Council Ref: DA2023/046 (10.2023.00000046.001)
Planning Panel Ref: PPSNTH-288-Gunnedah
NSW Planning Portal Ref: PAN-204159

RESPONSE TO COUNCIL REQUEST FOR ADDITIONAL INFORMATION (RFI): PROPOSED CONTINUATION & EXPANSION OF COUNCIL-OPERATED QUARRY, No. 809 OAKLEY CREEK ROAD, PIALLOWAY NSW 2342: "BOLGERS PIT"

Table 4.1: Response to Council's RFI

FIGURE F1: Bolgers Pit and nearest groundwater bores in same sub-catchment (Bores identified by yellow stars)

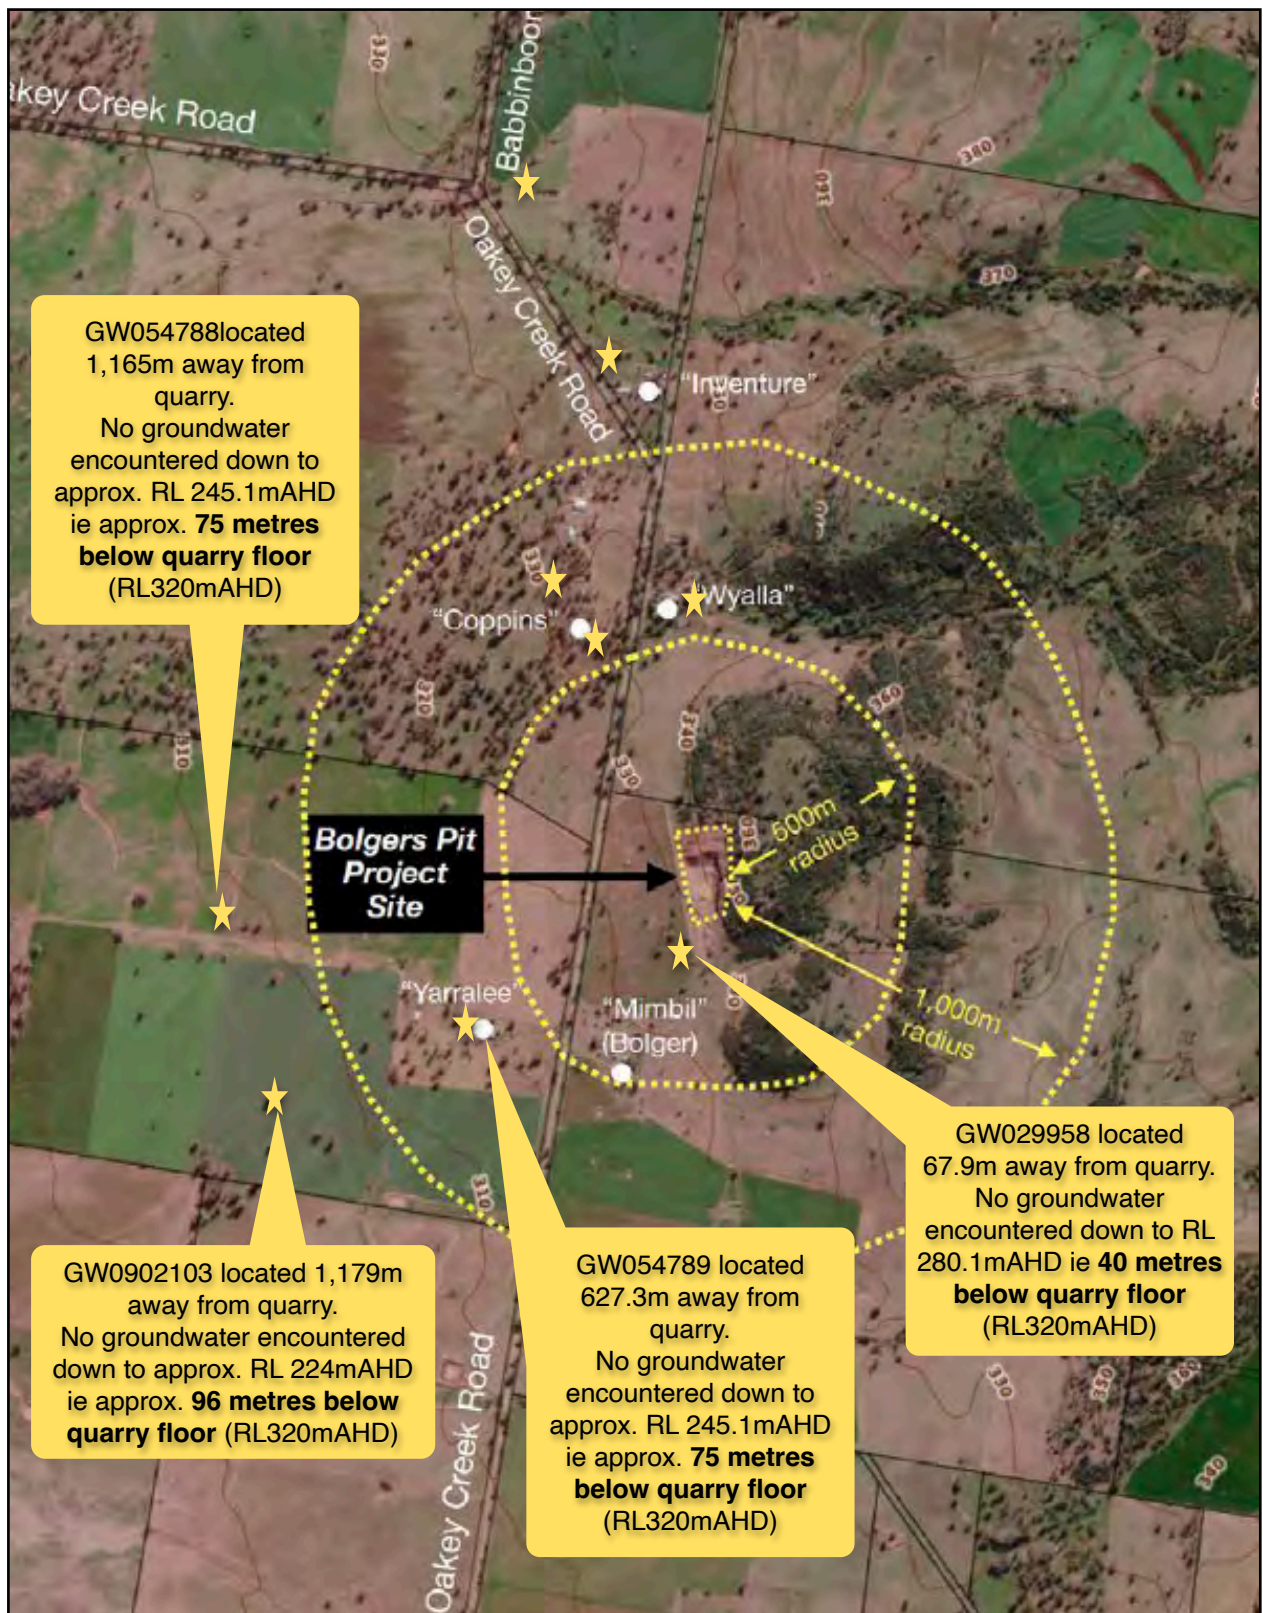
“(a) Provide comment regarding potential interaction of water within the Sump with Groundwater. Is there risk from water from within the Quarry footprint containing contaminants which may affect groundwater.”

- The EIS refers to a groundwater level of RL320m AHD. This is an overly conservative number. Instead, it is relevant to note that this is the inferred groundwater level at three site to the north of the site within a separate drainage sub-catchment and at elevation. However, at the two nearest licensed groundwater bores to the site, at bores 6 and 12 as identified in Figure 2.8 of the EIS, **groundwater is likely to be at least 40 metres below RL320m AHD.**

- At GW064563 (ground RL approx. 327mAHD), located only 67.9m away from the proposed quarry, identified as groundwater bore 6 in EIS Figure 2.8, no groundwater was encountered at a depth of 46.9m below ground level ie. RL 280.1m AHD, **40 metres below the floor level of the proposed quarry.**
- At GW054789 (ground RL approx. 300mAHD), located 627.3 away from the proposed quarry, identified as groundwater bore 12 in EIS Figure 2.8, no groundwater was encountered at a depth of 54.9m below ground level ie. RL 245.1mAHD, **75 metres below the floor level of the proposed quarry.**

Figure 3: Proposed expansion footprint and native vegetation clearing extent.

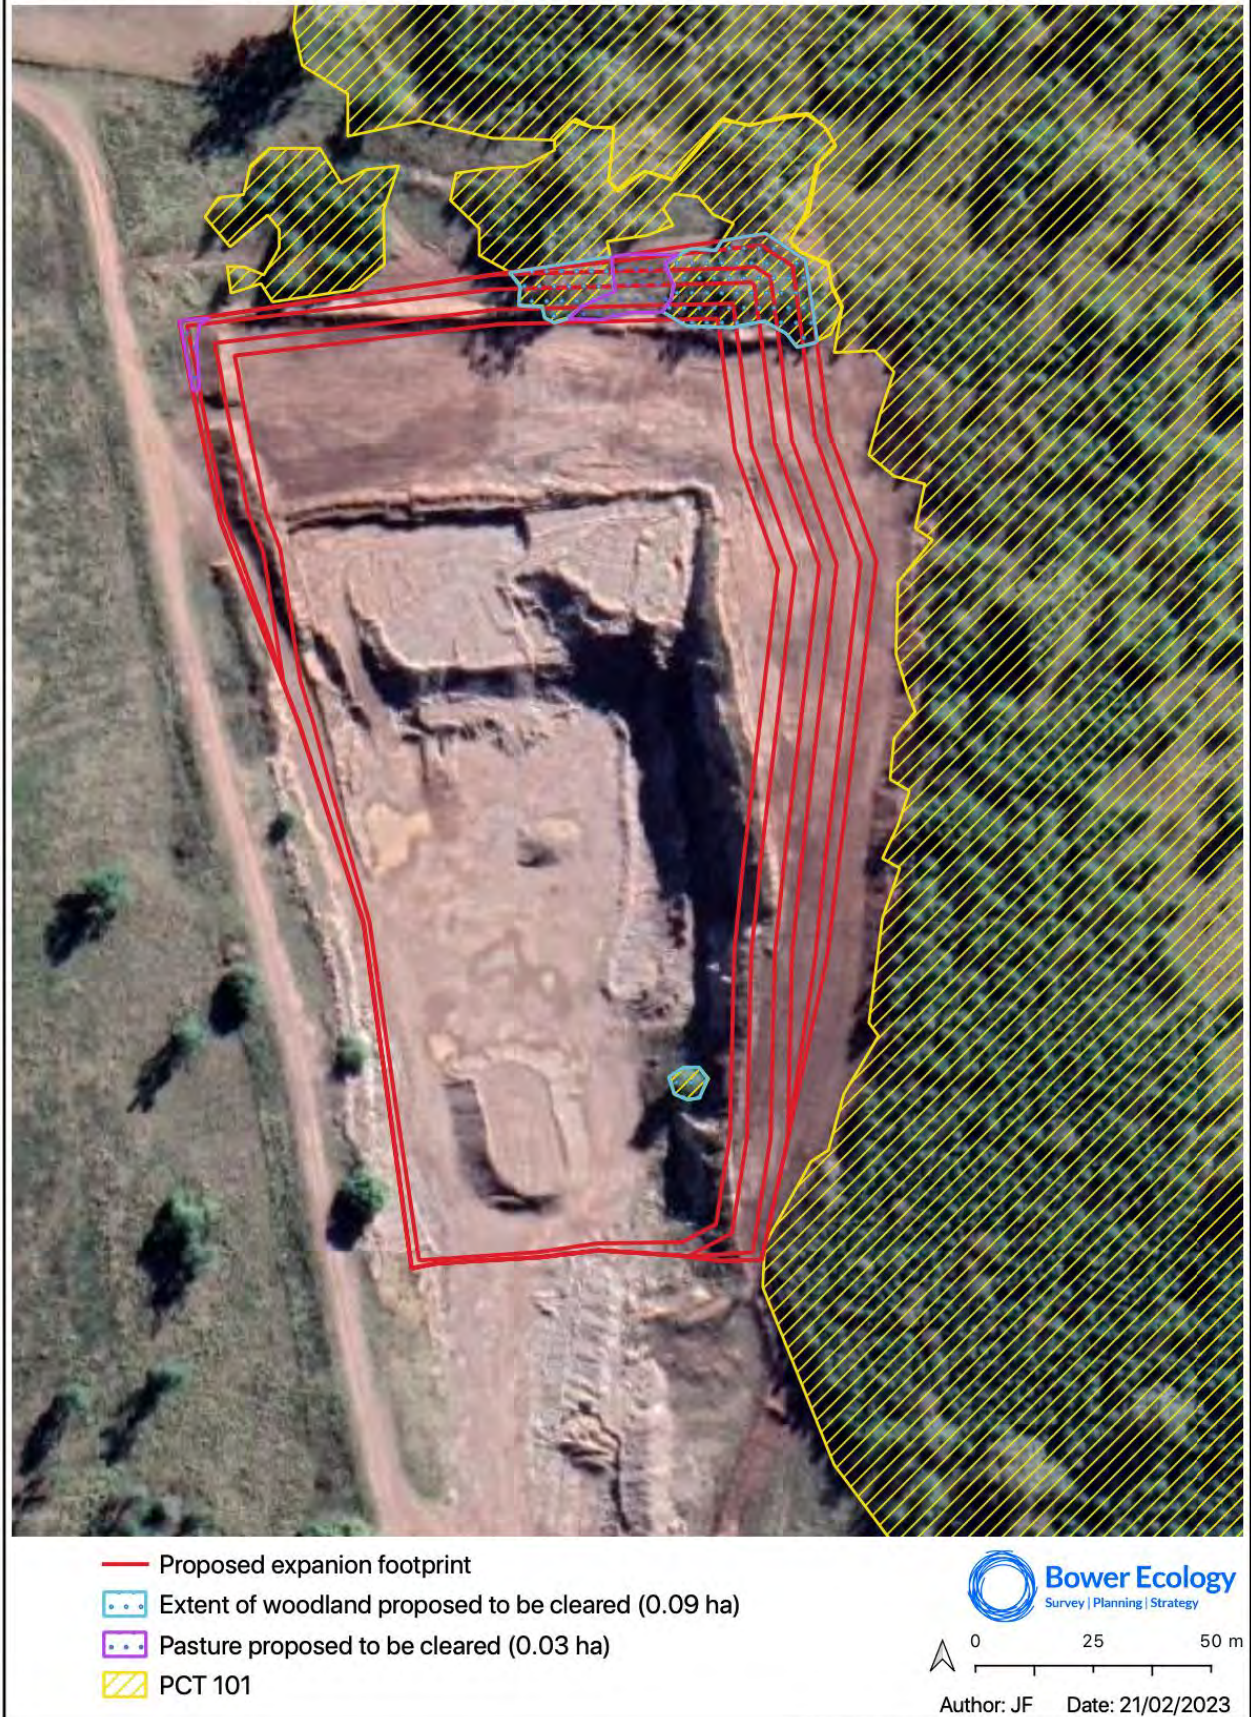
“(b) Identify the vegetation communities to be removed from site and provide detailed calculation of vegetation canopies to validate that the vegetation to the impacted is less than 1ha as per Section 7.2 of the Biodiversity Conservation Regulation 2017.”

Areal measurement of native vegetation via aerial photography was shown in Figure 12 of the Ecological Assessment. The same figure is reproduced below as Figure 2. The figure shows native vegetation clearing will be less than 1 ha.
